DESCRIPTION OF PROPOSED CHANGES NPF-10-8 AND NPF-15-8  
AND SAFETY ANALYSIS

This is a request to revise Technical Specification 3/4.6.3 - "Containment Isolation Valves."

Figure 3.1-3

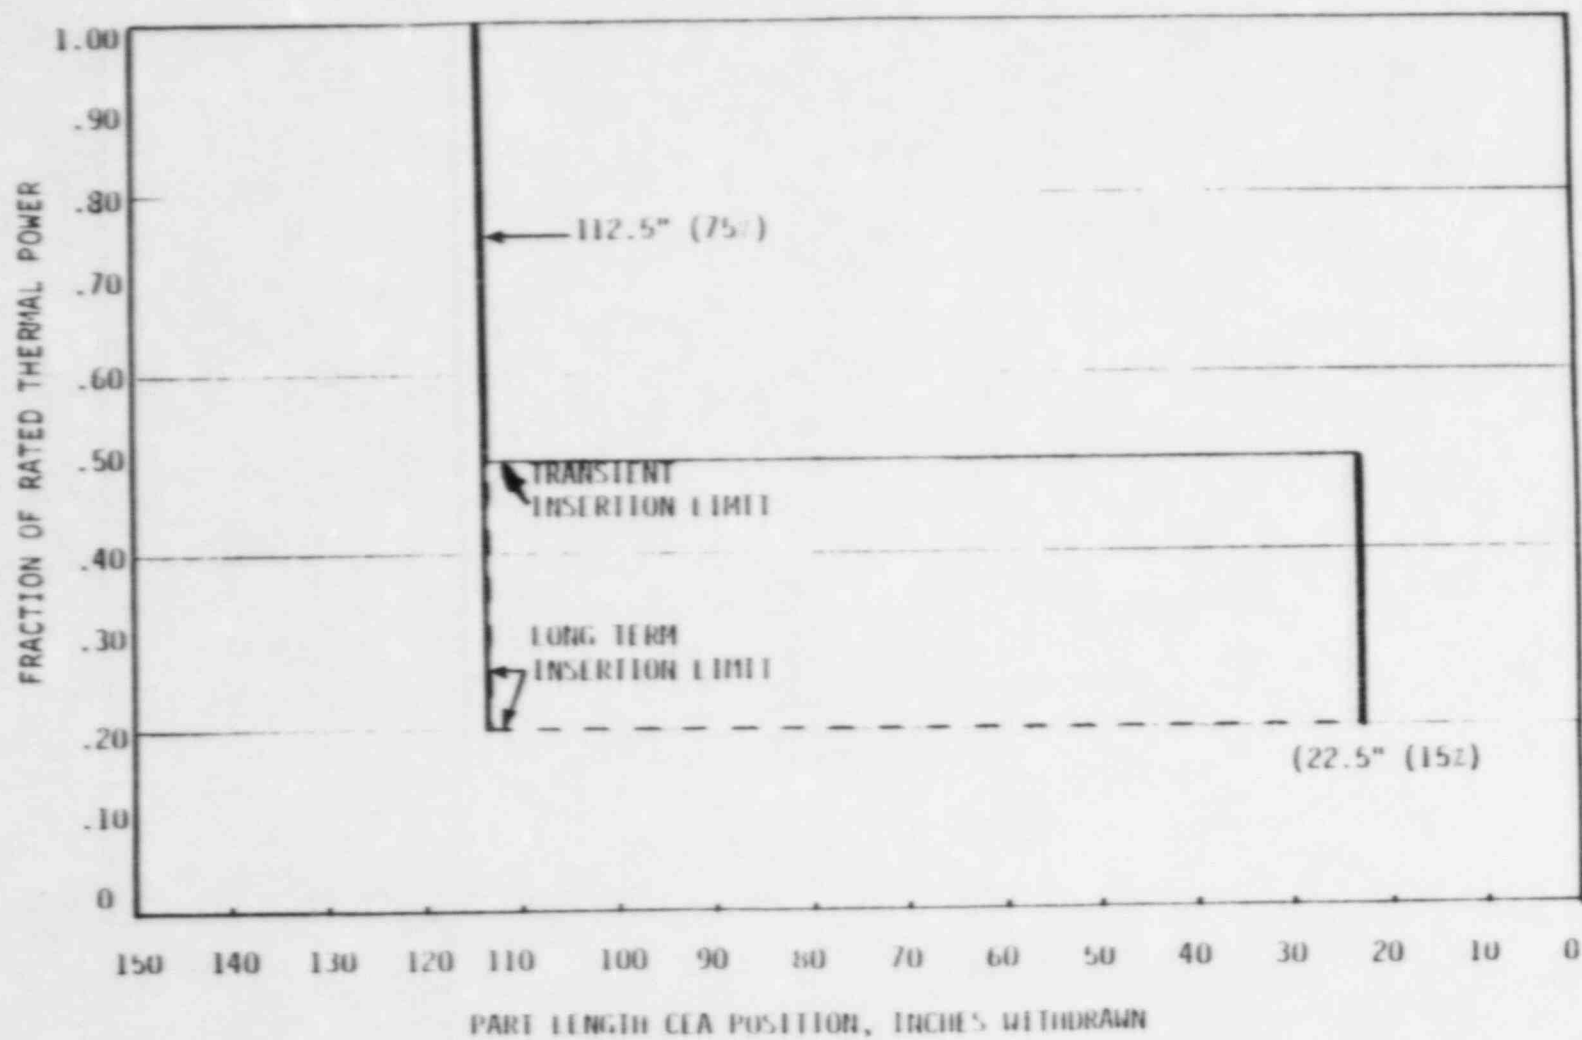
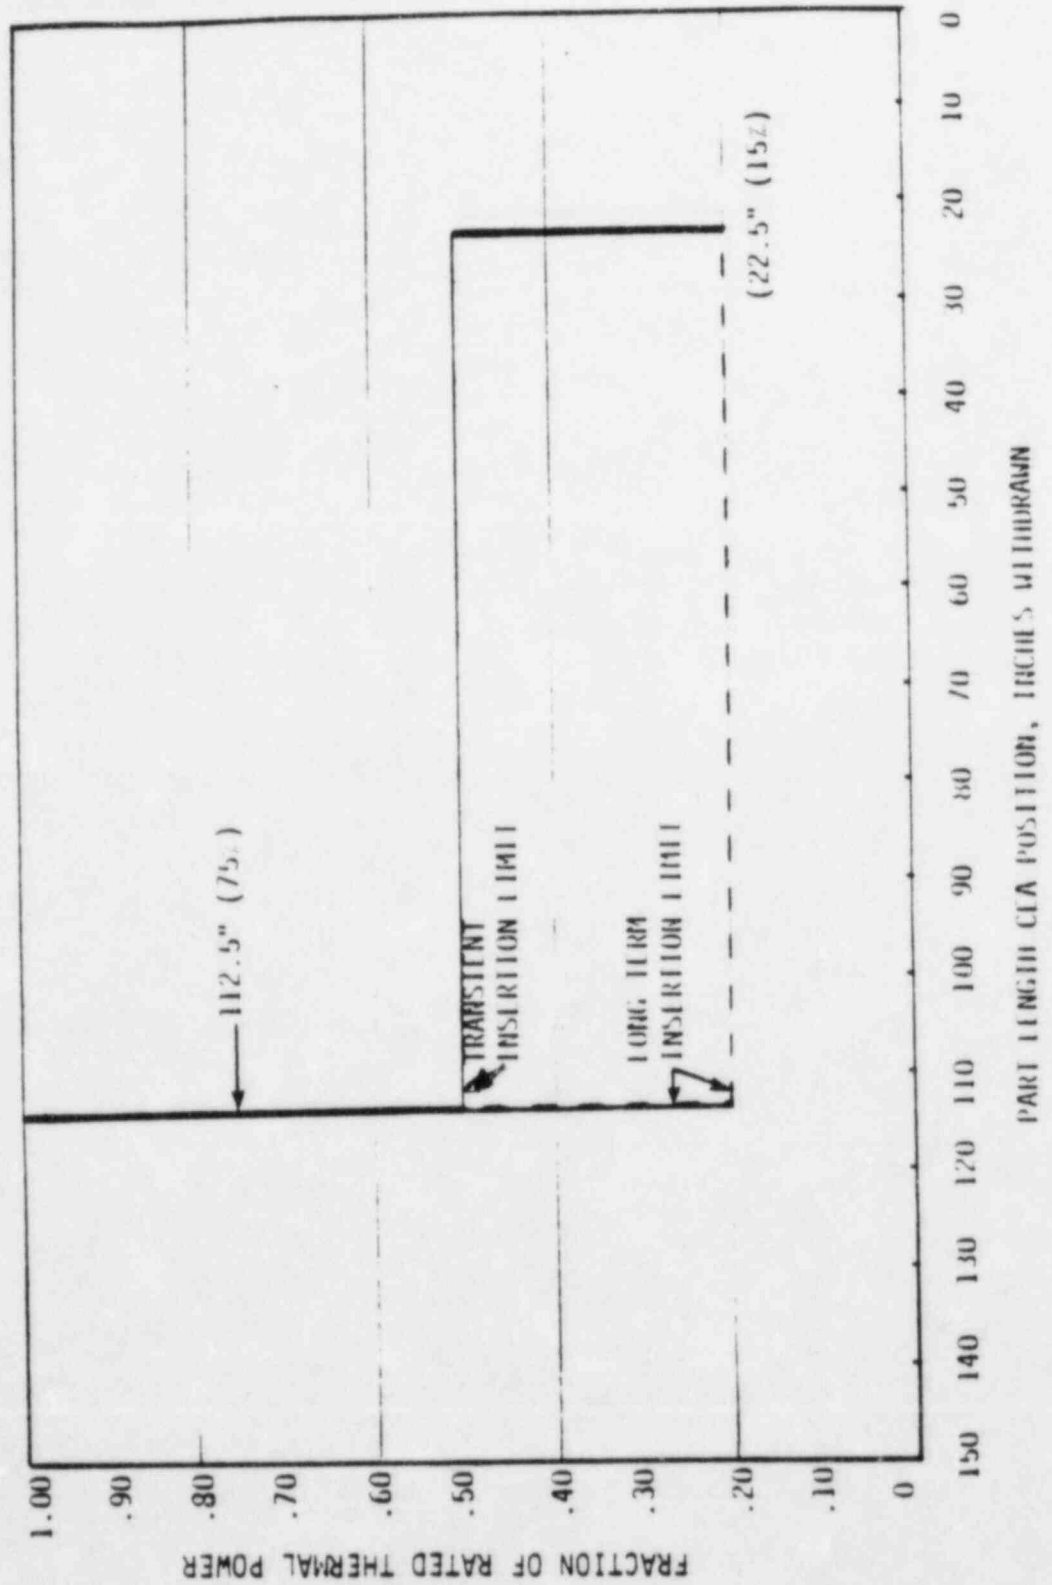
3.1.3.7 The position of the part length CEA group shall be restricted to prevent the neutron absorber section of the part length CEA group from covering the same axial segment of the fuel assemblies for a period in excess of 7 EFPD out of any 30 EFPD period. The position of the part length CEA group shall also be limited to the insertion limits shown on Figure 3.1-3.
